Report

To Michael MacDonagh
From Michael Lewis & James Espagne
Project Name North East Growth Corridor
Subject Desktop Drainage Strategy Review

Date 09 March 2016
Reference 302389/R01

Figure 1 Reeds Consulting NEGC Drainage Catchment Plan.

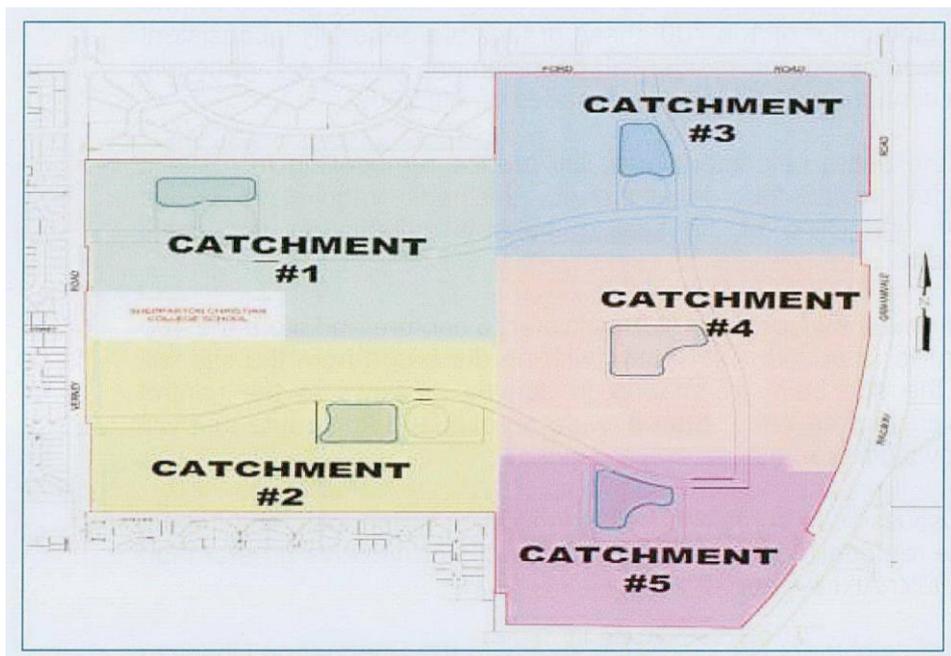
A review of the existing survey information supplied by GSCC shows the natural fall of the land is grading east to west across the site. After analysing the catchment Spiire proposes to split the NEGC into 4 catchments. Refer to the drainage catchment plan in Appendix A showing the proposed catchment boundaries.

By reducing the catchments from 5 to 4 it has increased the overall size of catchments 3 and 4 by consolidating catchments 3, 4 and 5 from Figure 1. These catchments were merged because of the relatively flat ground when compared to catchments 1 and 2.

A review of Reeds Consulting basin for catchment 1 and the associated documentation provided for water sensitive urban design (WSUD) treatment of the catchment conforms to industry standards. Spiire agrees with the catchment 1 analysis undertaken by Reeds Consulting, agreeing with their approach to drain the catchment to the North West corner.

Appendix A – Drainage Catchment Plan

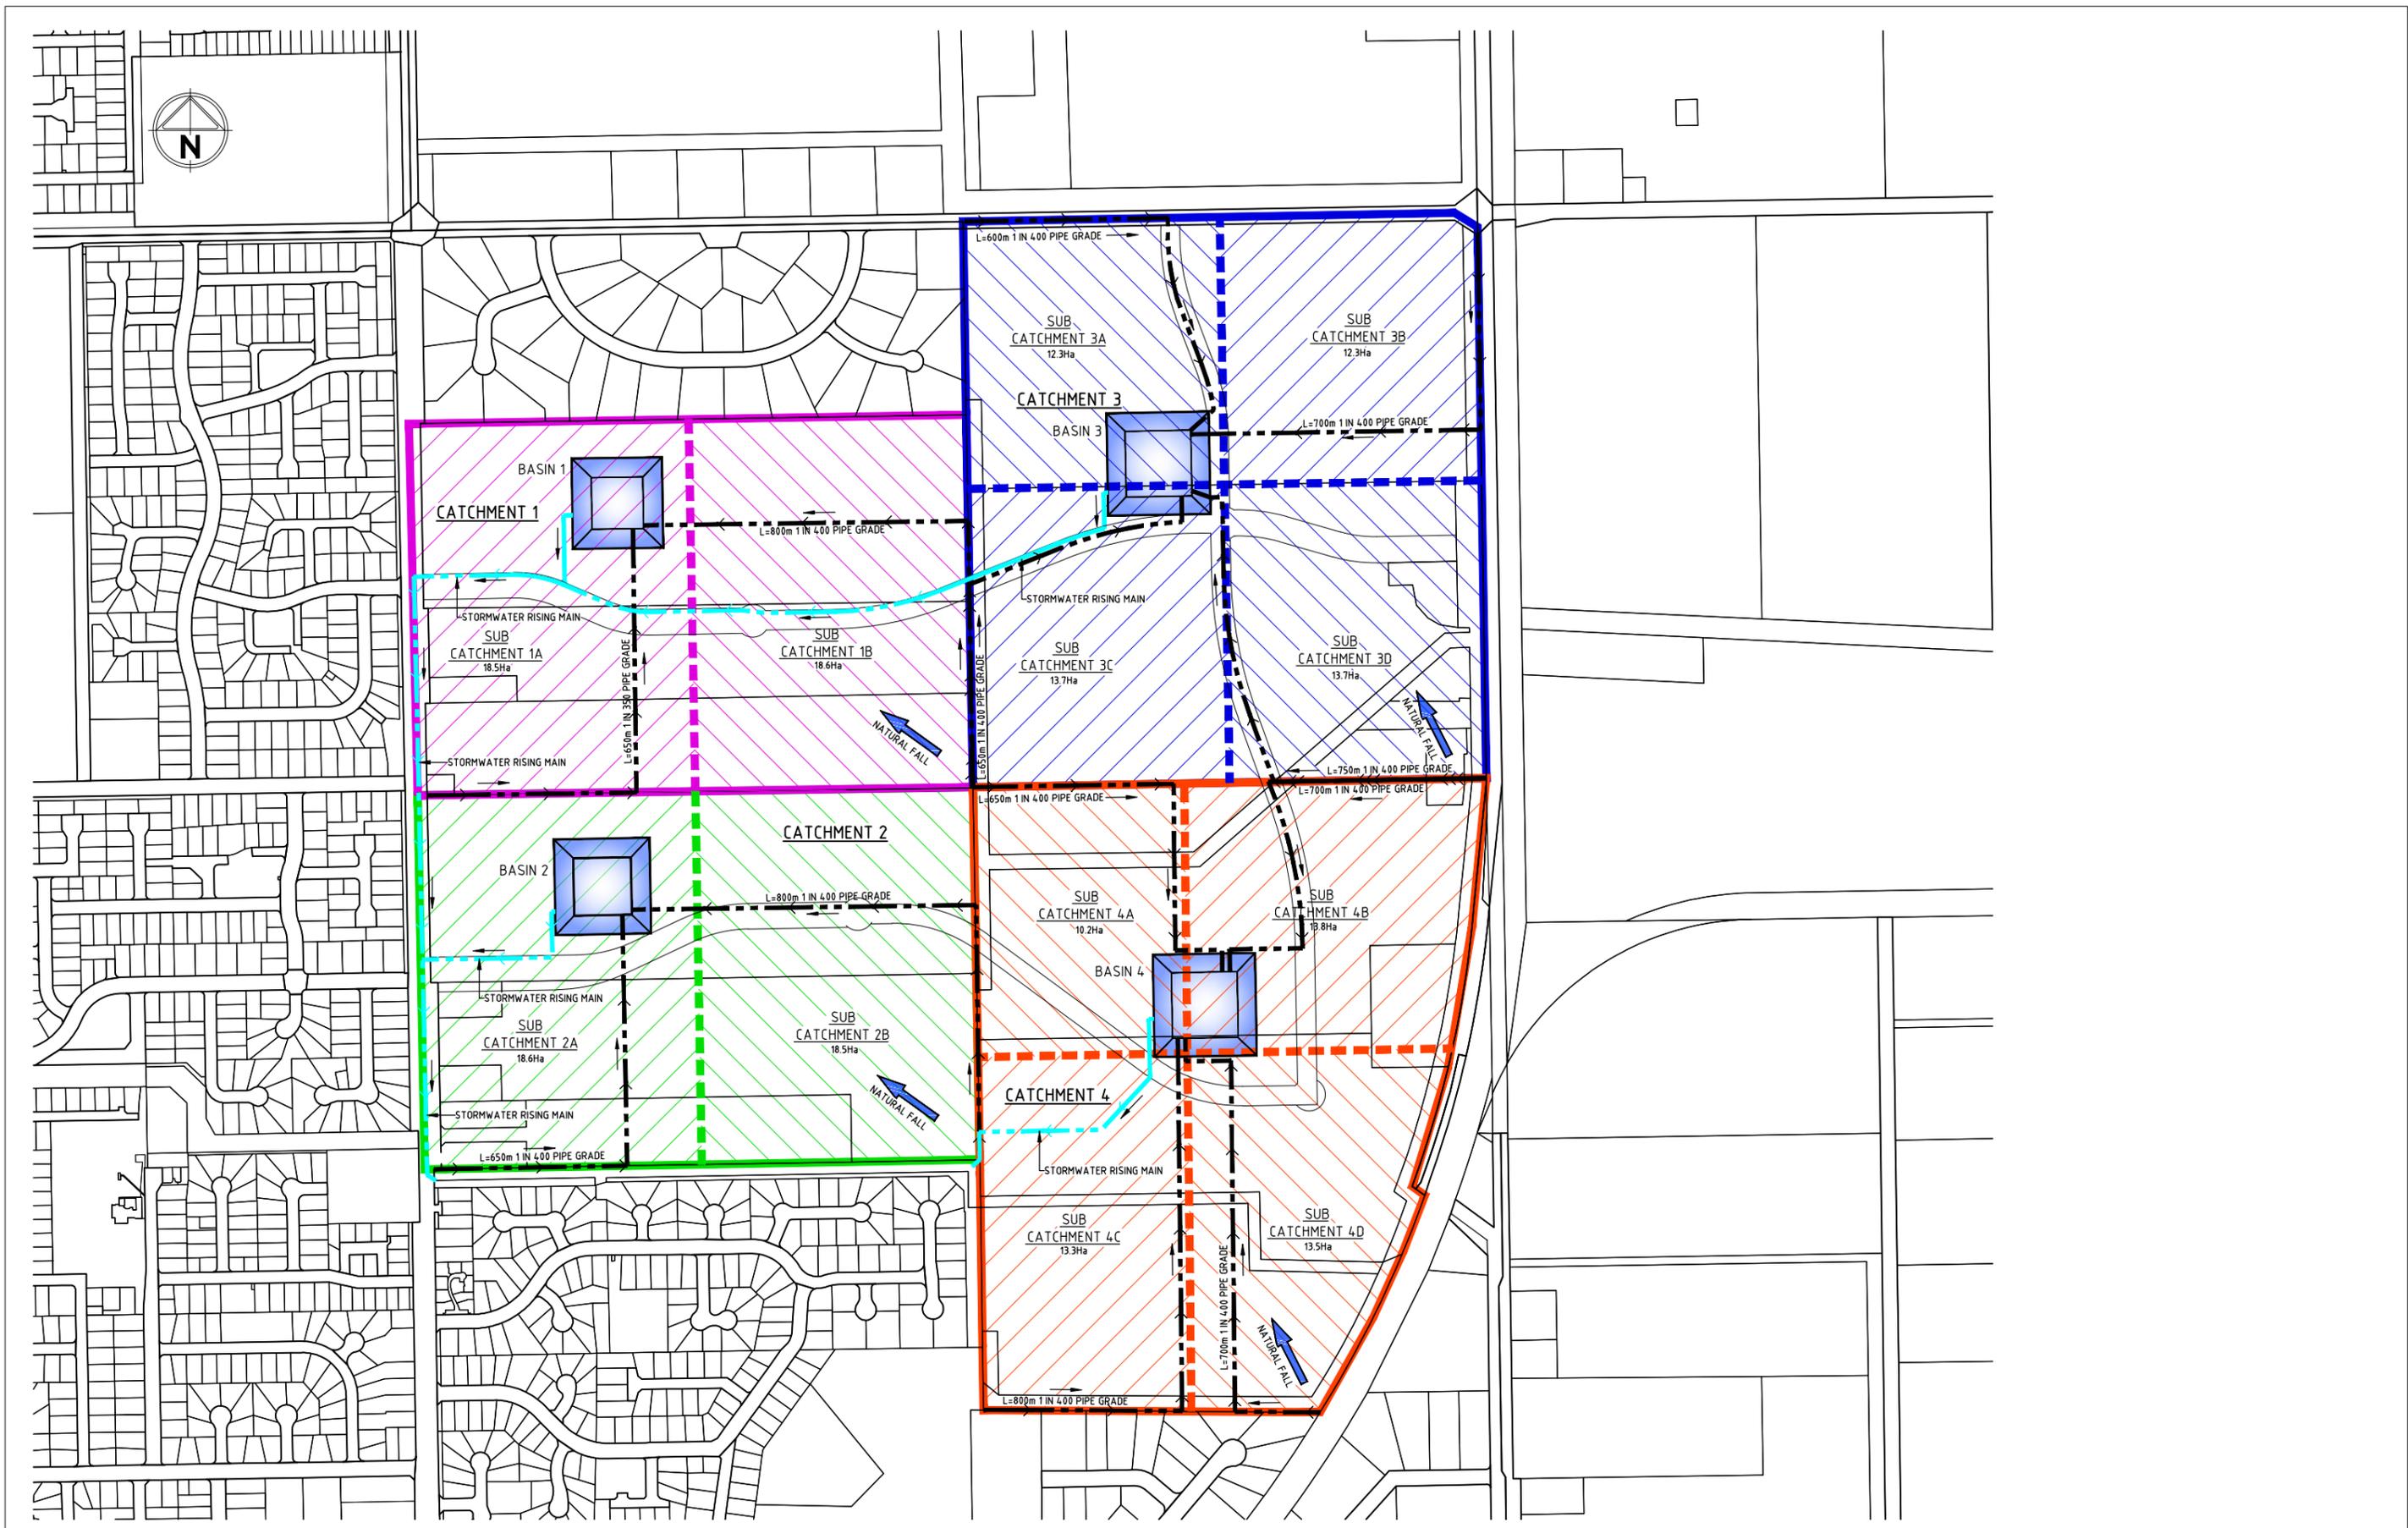
As shown in Appendix A catchments 1 and 2 are located on the west side of the corridor and catchments 3 and 4 are located on the eastern side to utilise the available grades.

The natural grade on catchments 1 and 2 is approximately 1 in 620 towards Verney Road from the eastern catchment boundary. Due to the significant grade over the land the basin location is critical in reducing the earthwork volumes across the development. Therefore basins 1 and 2 have been located in the North West corners of their catchments to maximise the grade of the land and to allow the 100 year overland flows to enter the basin. By locating the basins in the lowest area of the catchment it also reduces the final depth of the basin as the underground drainage and the land are grading in the same direction.

Catchments 3 and 4 continue to grade west; however, it is not as significant as catchments 1 and 2. The grade across the catchments is approximately 1 in 2400 from the eastern and southern catchment boundaries. Due to these catchment being quite flat the basin location is not as critical as discussed catchments 1 and 2. Therefore the basins have been located in the centre of each catchment to reduce the pipe lengths and overall depth of basins.

The reduction from 5 to 4 basins has resulted in larger basins being required for catchments 3 and 4. However, the drainage infrastructure required for the NEGC has been reduced for construction costs and future maintenance costs with the reduction of pump stations, rising mains, WSUD treatment systems, etc. With these reductions it will have a significant impact on the overall costings for the growth corridor drainage. Refer to Appendix A showing the basin locations and catchment boundaries.
